ATTACHMENT TO WNP-2 SINGLE LOOP OPERATION SUMMARY REPORT
TECHNICAL SPECIFICATION CHANGES (INCLUDING JUSTIFICATION)

JUSTIFICATION FOR CHANGES TO TECHNICAL SPECIFICATION 3.3.10

JUSTIFICATION TO CHANGES to 3/4.1.1

Maximum Average Planar Linear Heat
Generation Rate (MAPLHGR) Versus
BUNDLE AVERAGE EXPOSURE
ANF 8x8 Reload Fuel
Figure 3.2.1-6

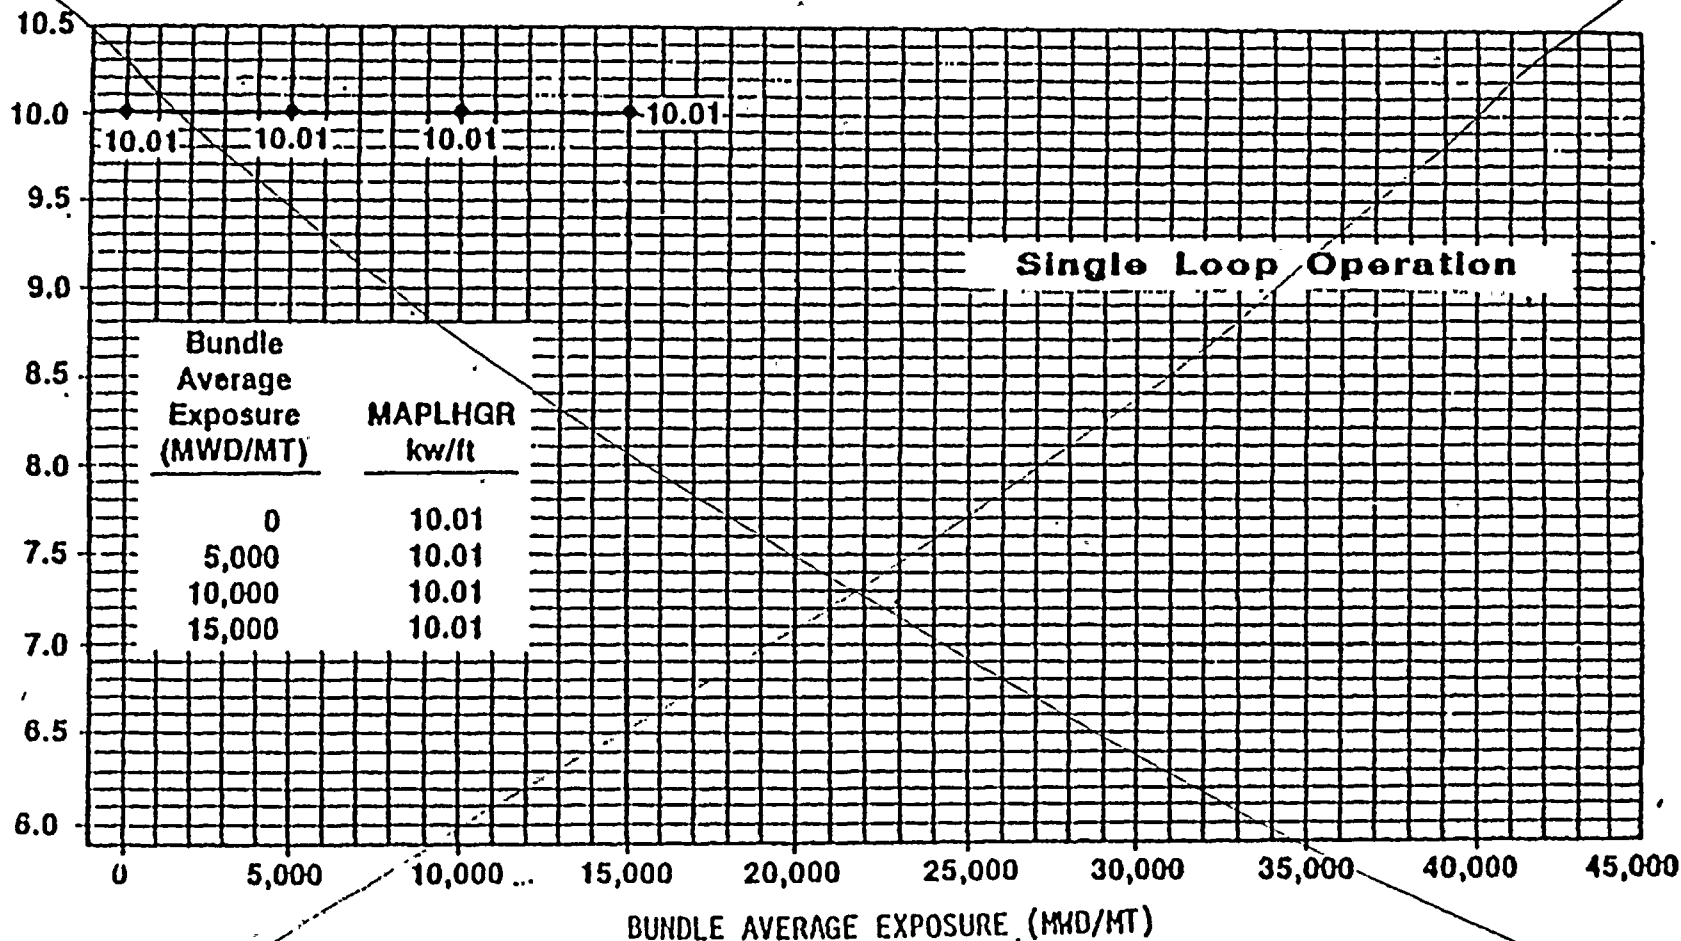
DELETE

Operating Region
Thermal Power Limits of Specification
Figure 3.2.6-1
3.2.6
X.X.X

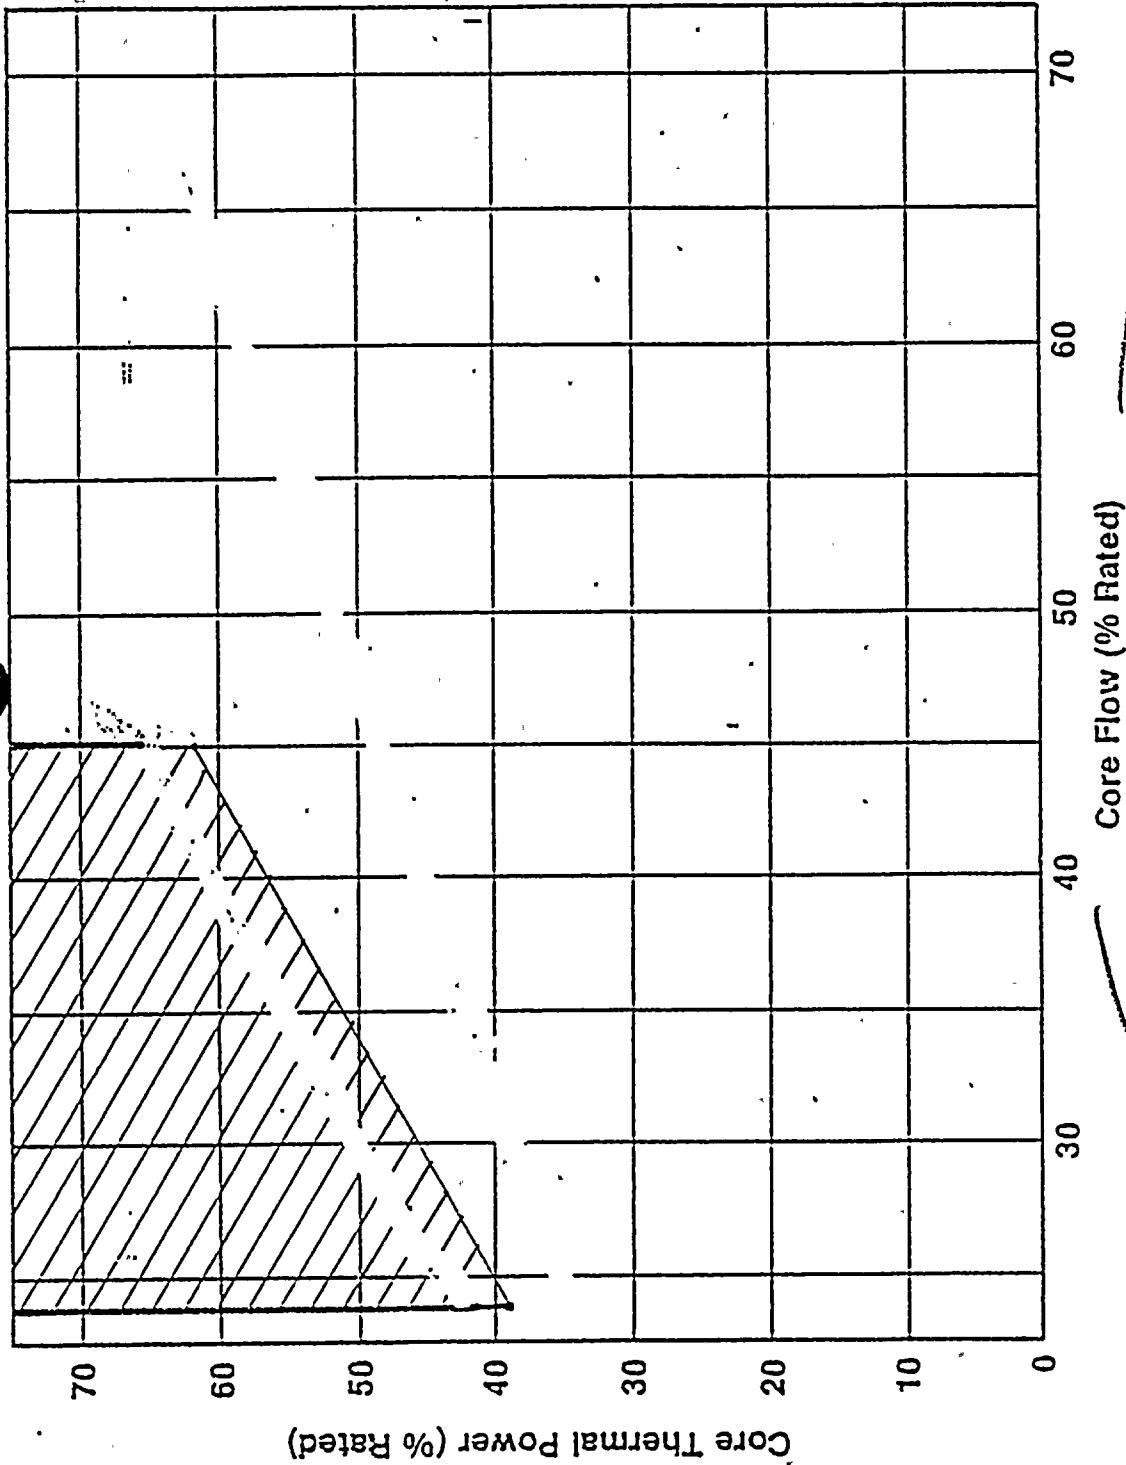
3.2.6 Operation with THERMAL POWER/core flow conditions which lay in the crosshatched region of Figure 3.2.6-1 is prohibited.

With THERMAL POWER/core flow conditions which lay in the crosshatched region of Figure 3.2.6-1, initiate corrective action within 15 minutes to establish a THERMAL POWER/core flow condition which lays outside the crosshatched region within 2 hours.

4.2.6 The THERMAL POWER/core flow conditions shall be verified to lay outside the crosshatched region of Figure 3.2.6-1 once per 24 hours.

OPERATING REGION
 Thermal Power Limits of Specification 3.2.7-1
 Figure 3.3.10-1
 3.2.7.-1

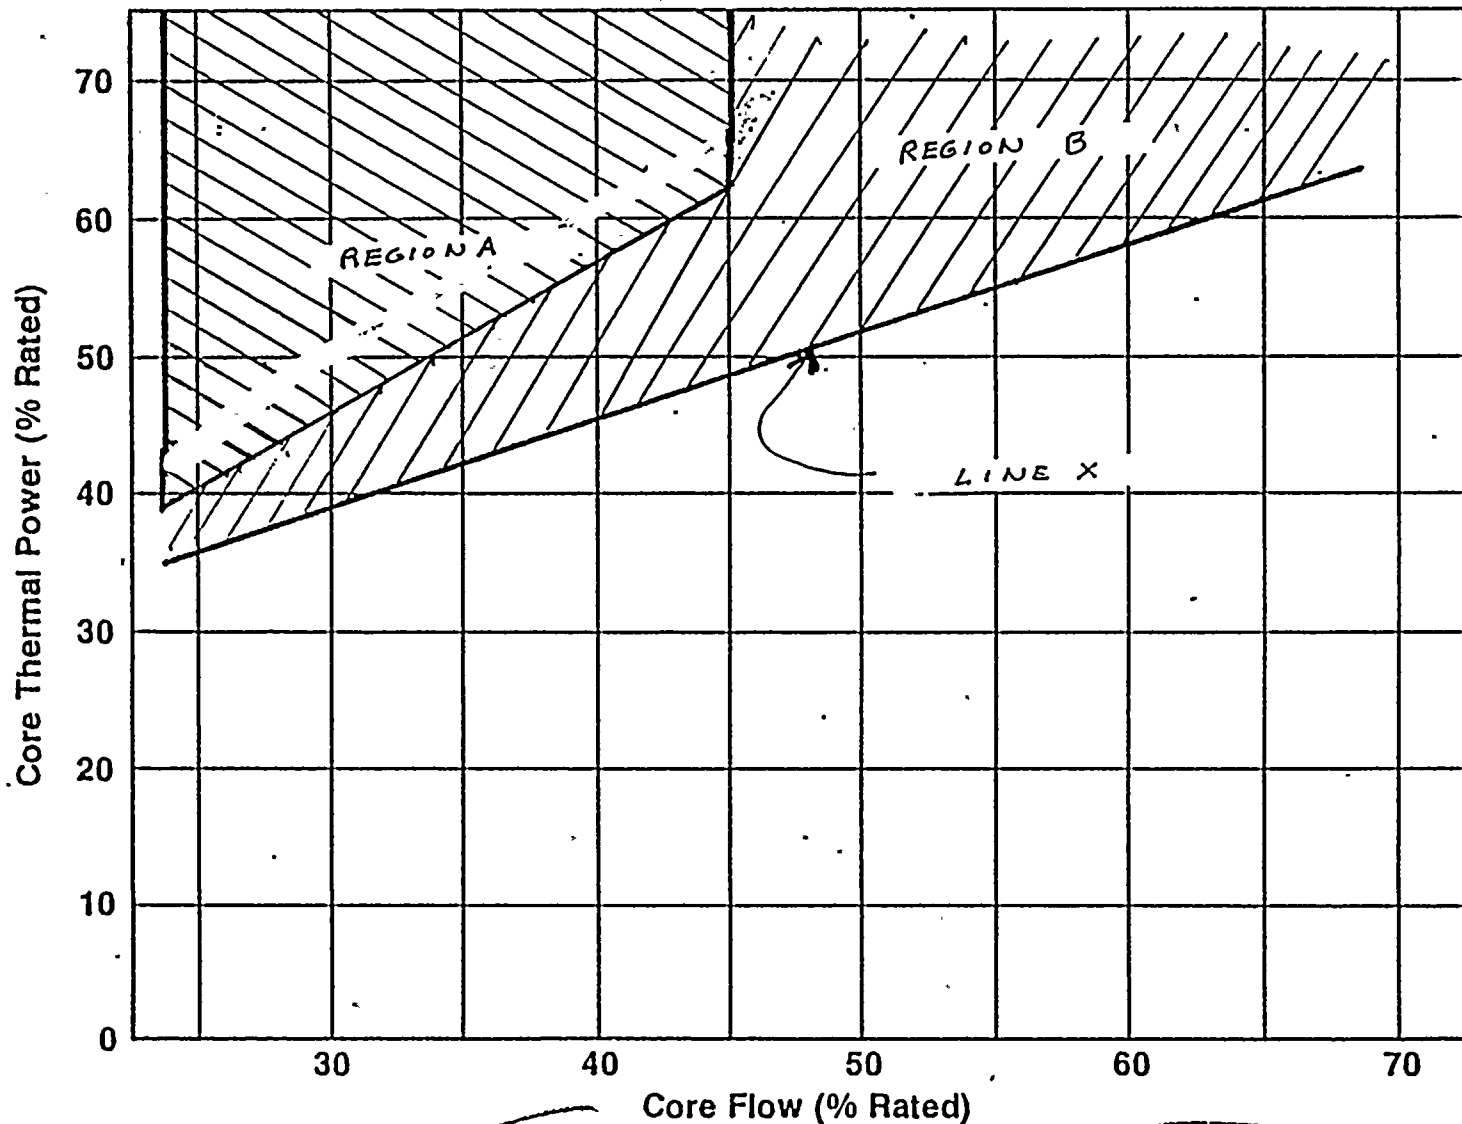
- 5) Modify Figure 3.3.10-1 (old) to more clearly identify the separate regions where 1) noise monitoring is required, and 2) operation is prohibited.
- 6) Remove ACTION statement b. from 3.3.10 and incorporate it in a separate LCO, 3/4.2.6, Power/Flow Stability. Currently, this ACTION statement exists with no stated LCO.

APPLICABILITY: OPERATIONAL CONDITION 1 with THERMAL POWER/core flow in Region B of Figure 3.2.7-1, with two reactor coolant system recirculation loops in operation and total core flow less than 45% of rated total core flow, or with one reactor coolant system recirculation loop not in operation.

Within 2 hours exit the region of APPLICABILITY. Establish baseline APRM and LPRM neutron flux noise levels prior to re-entering Region B of Figure 3.2.7-1.

Thermal Power Limits of Specification 3.3.10-1
Figure 3.3.10-1

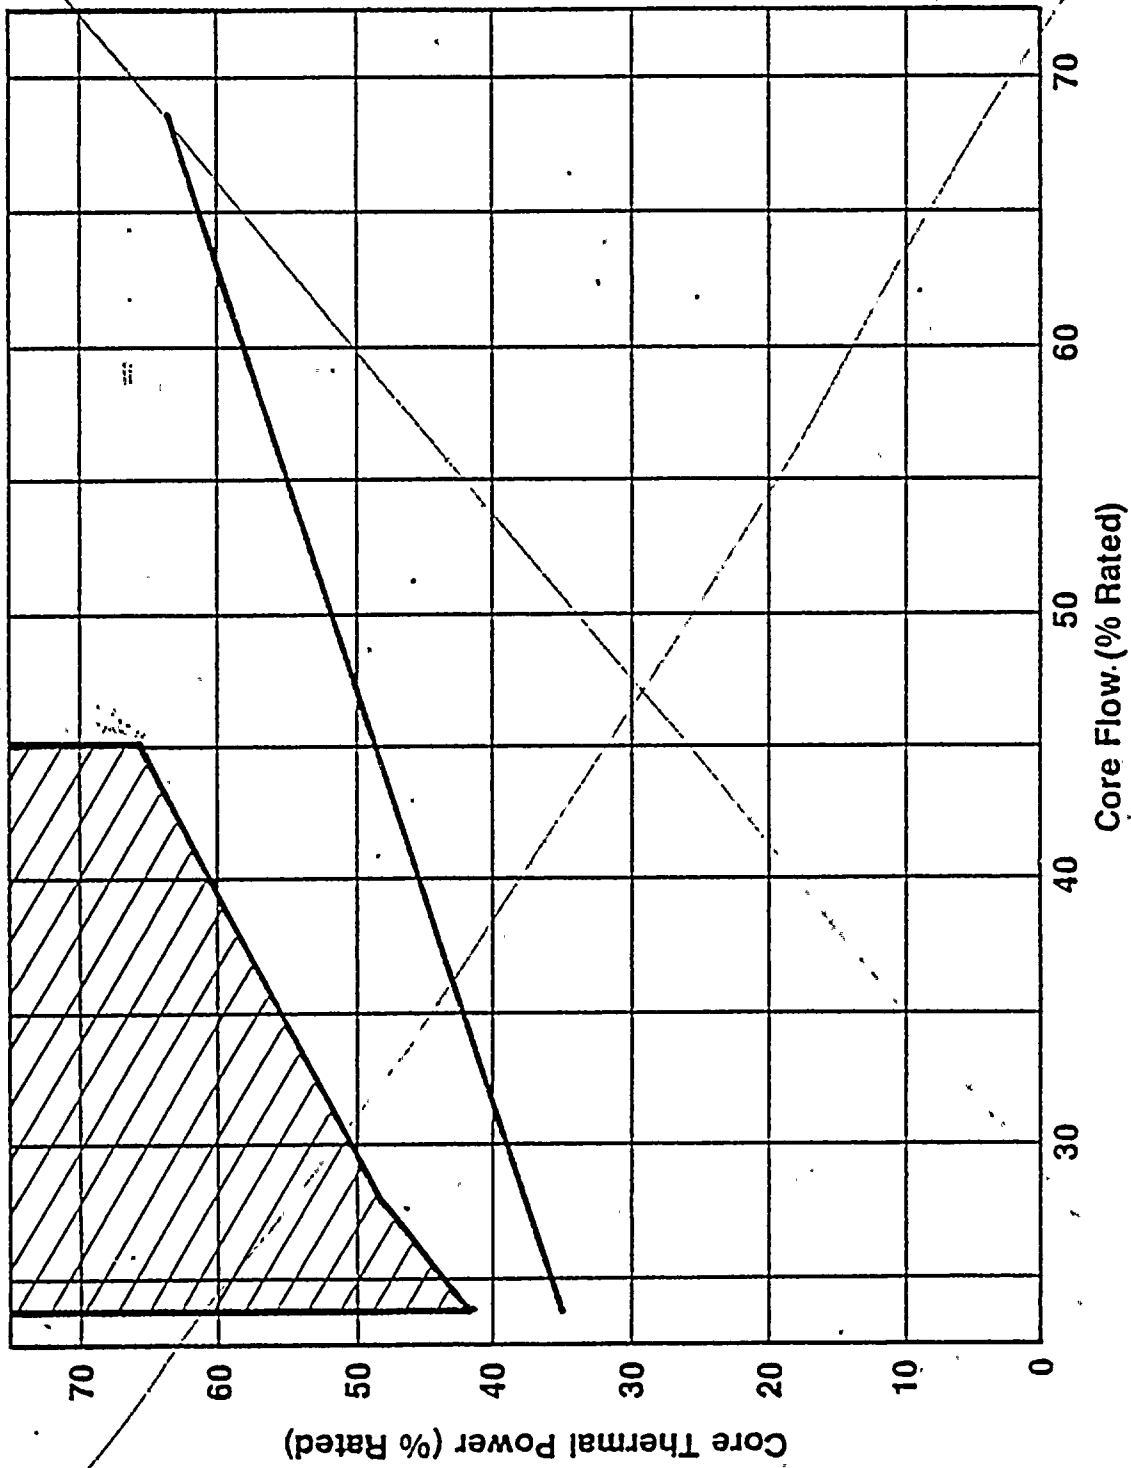
DELETE
